Technical Sheet

Over-Pressure Latching Relay

(Replacement for TS30/TS33 Pressure Indicator Option "E" - T3010431Y)

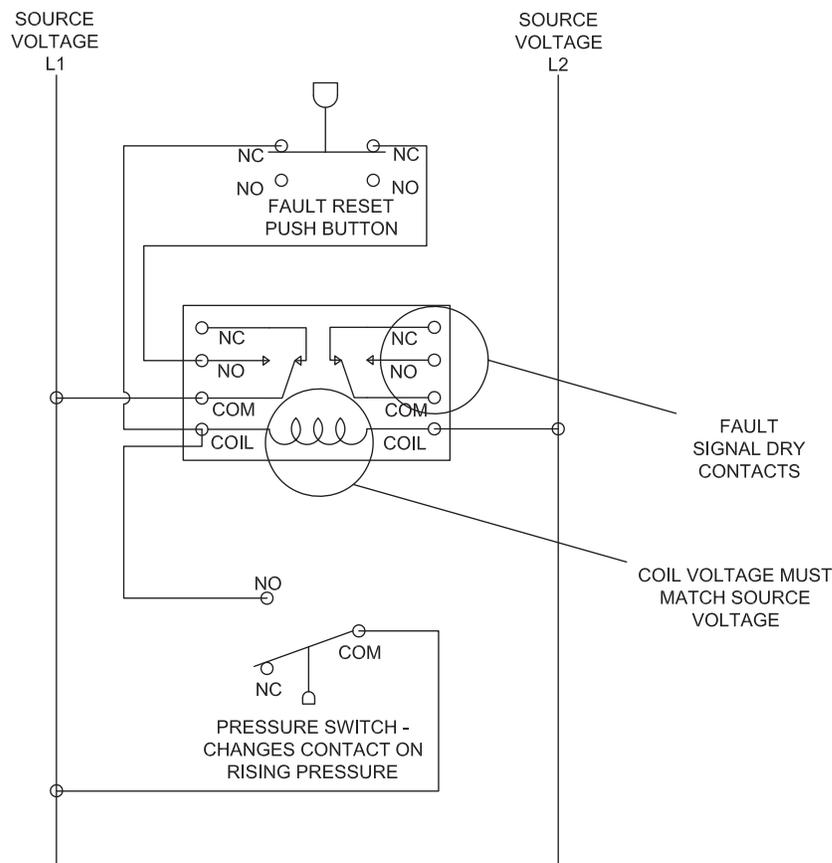
To replace the discontinued rupture disc indication for stations with an electrical one.

- 1 relay DPST voltage specific to the control scheme of the customers system. (Customer Supplied)
- 1 pressure switch specific to pressure range of customers system type. (Included in kit 85287, 27445-4 is pre-set @ 1200 psi, adjustable range 500-4700 psi)
- 1 normally closed push button to reset fault. (Customer Supplied)
- Miscellaneous wiring and connectors to assemble it all together. (Customer Supplied)

- See below schematic for reference.
- Constant voltage is applied to common of relay.
- When the pressure switch closes voltage from the output of the switch closes the relay which is wired with a latching circuit.
- This is held closed with the use of the normally closed switch. The other side of the relay provides a dry contact for the customer fault. Once pressure has been relieved the reset button can be pushed releasing the latch and resetting the fault signal.
